ORIGINATION FORM

Proposed Revisions to a Standard Plans Index (Please provide all information — Incomplete forms will be returned)

Index Number: 521-428

Index Title: Traffic Railing - (42" Single-Slope)

LAST REVISION	DESCRIPTION	FDOT	FY 2020-21 STANDARD PLANS	TRAFFIC RAILING - (42" SINGLE-SLOPE)	INDEX	SHEET
11/01/18					521-428	1 of 4

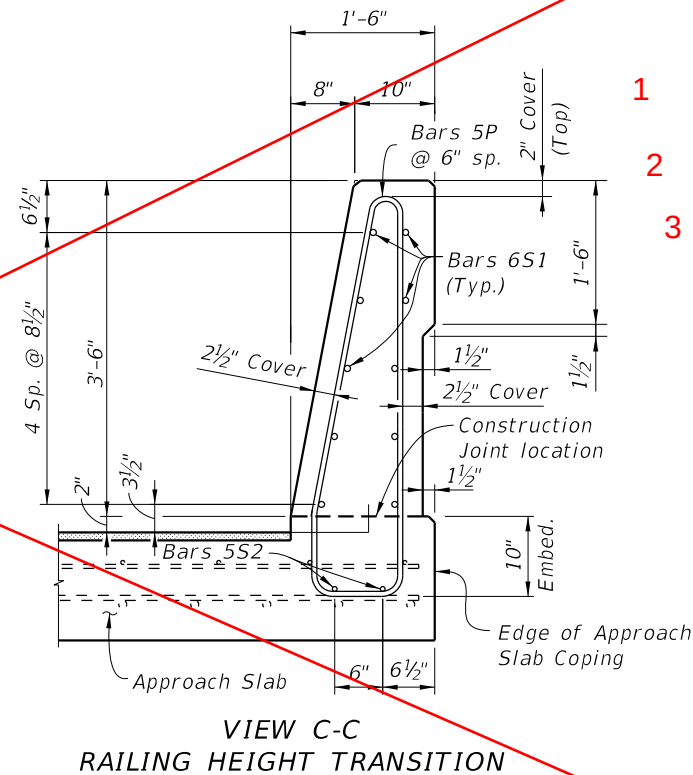
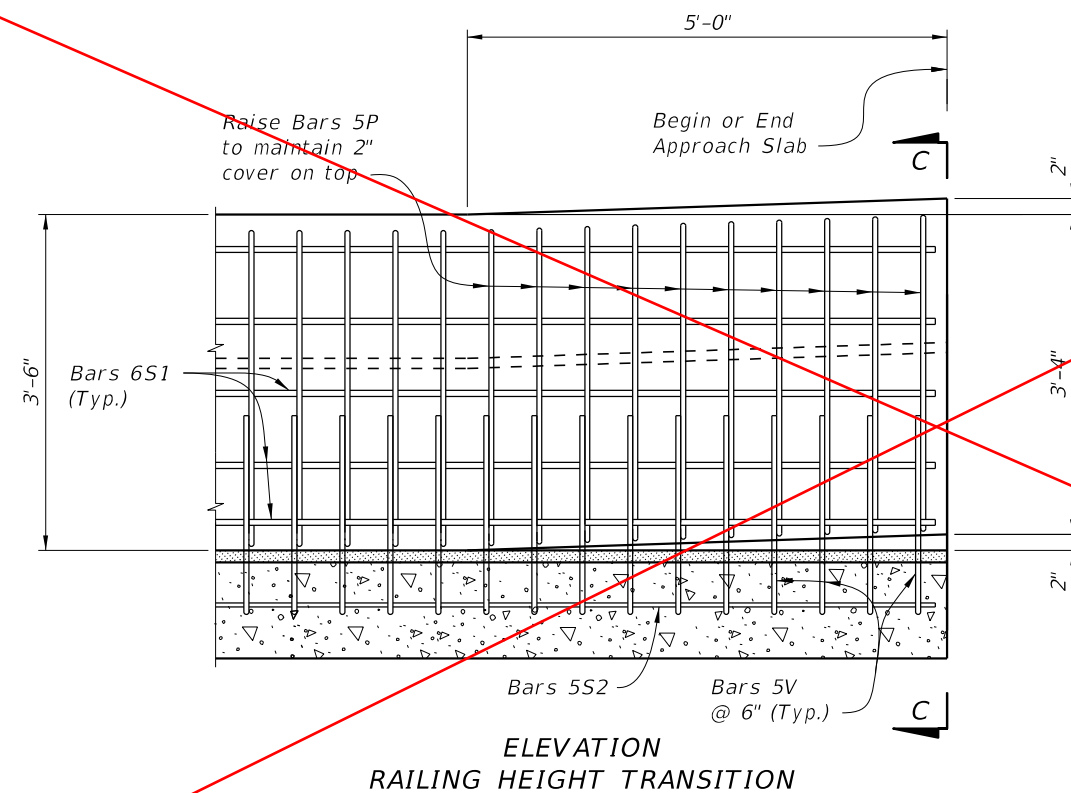
Sheet 1: Numbered and reorganized notes; Added drainage slot information; Clarified the height transitions; Deleted crash rating; Sheet 3: Changed height transitions (deleted transition to 44") Changed Notes

~~This railing has been structurally evaluated to be equivalent or greater in strength to other single slope railings which have been crash tested to MASH TL-5.~~

Numbered and reorganized notes. Added note on transitions.

DRAINAGE SLOTS: When shown in the plans, see Index 521-427 Sheet 5 for details.

DETAIL "B"

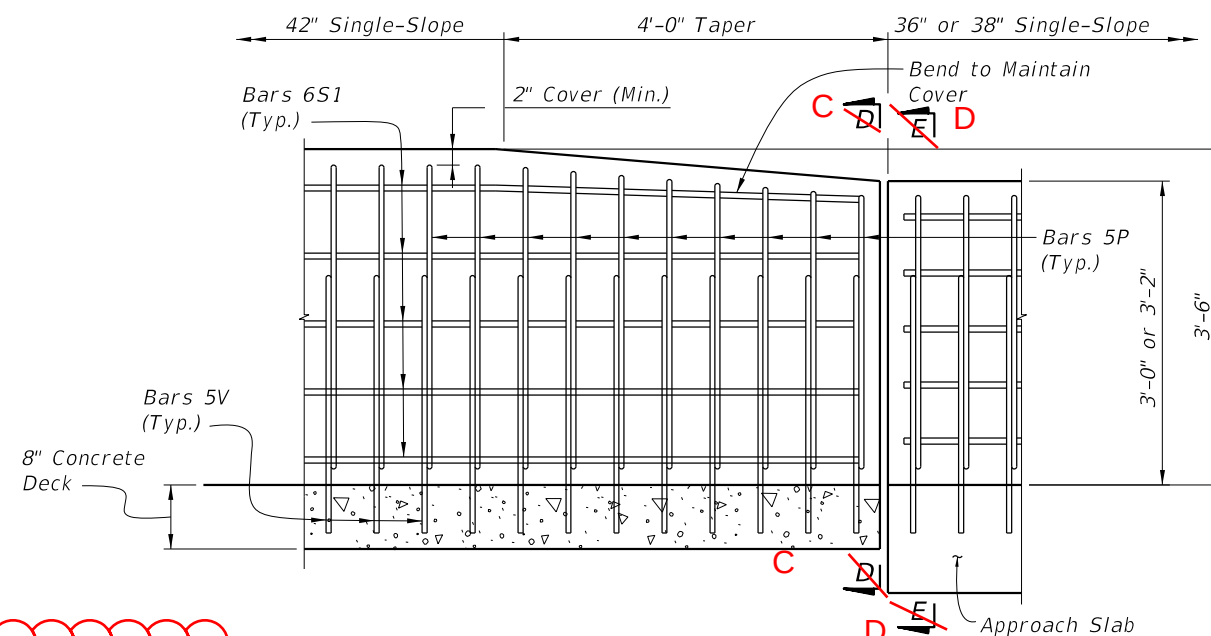
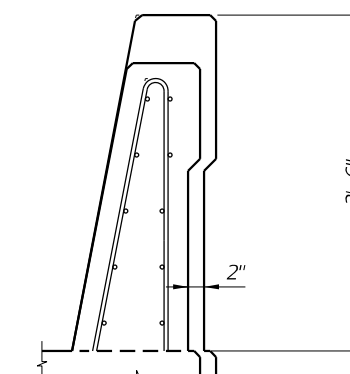
MASH crash criteria met is in the SPI (not a construction note). Numbered notes to make them consistent with other Indexes and within the Single-Slope Traffic Railings. Sheet 2 deleted Detail "B" because it is included in 521-610 and does not transition to 44" Roadway Barriers which are for pier protection-different shape.

1. ~~Provide Detail "B" height transition where 42" Single Slope Traffic Railings increase to 44" Barriers beyond flexible pavement approaches.~~
2. ~~Work Detail "B" with Index 400-090.~~
3. ~~Provide Detail "B" height transition where 42" Traffic Railings are required on bridge, and 36" or 38" Barriers are shown on approaches.~~
4. ~~Work Detail "B" with Indexes 400-090 or 400-091, 521-427, and 521-610 as necessary.~~
5. ~~Field cut 5P Bars as shown to maintain 2" min. (4" max.) cover at top of traffic railing.~~

VIEW ~~D-D~~ ~~C-C~~
RAILING HEIGHT TRANSITION
(Begin/End of Bridge)
(Bars 5V not shown for clarity)

SECTION ~~E-E~~ ~~D-D~~
(Index 400-091 Shown, 400-090 Similar)
(Index 521-427 Bars 4V not shown for Clarity)

DETAIL "B"

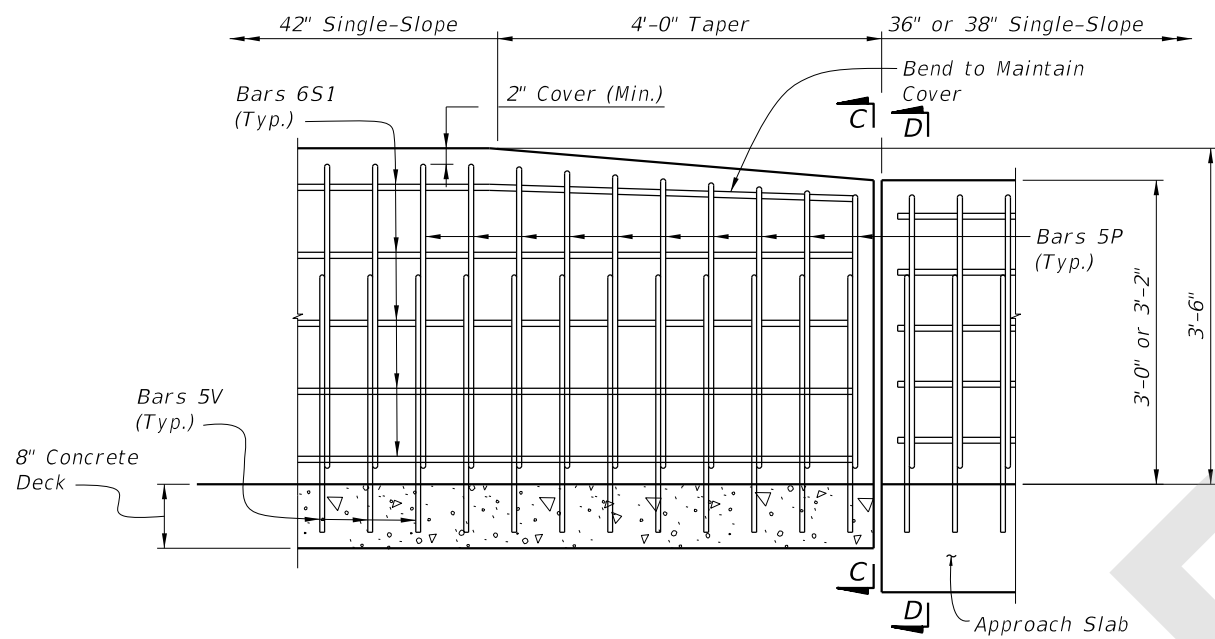
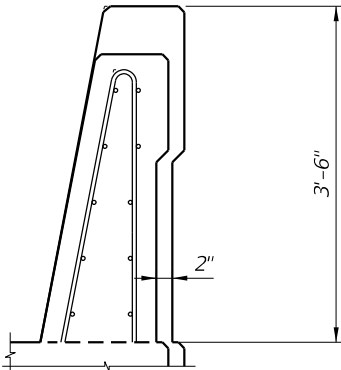
- NOTE:
- 1. Provide Detail "C" height transition where 42" Traffic Railings are required on bridge, and 36" or 38" Barriers are shown on approaches. See Structures Plans for coping details.
 - 2. Work Detail "C" with Indexes 400-090 or 400-091, 521-427, and 521-610 as necessary.
 - 3. Field cut 5P Bars as shown to maintain 2" min. (4" max.) cover at top of traffic railing.

VIEW C-C
RAILING HEIGHT TRANSITION
(Begin/End of Bridge)
(Bars 5V not shown for clarity)

SECTION D-D
(Index 400-091 Shown, 400-090 Similar)
(Index 521-427 Bars 4V not shown for Clarity)
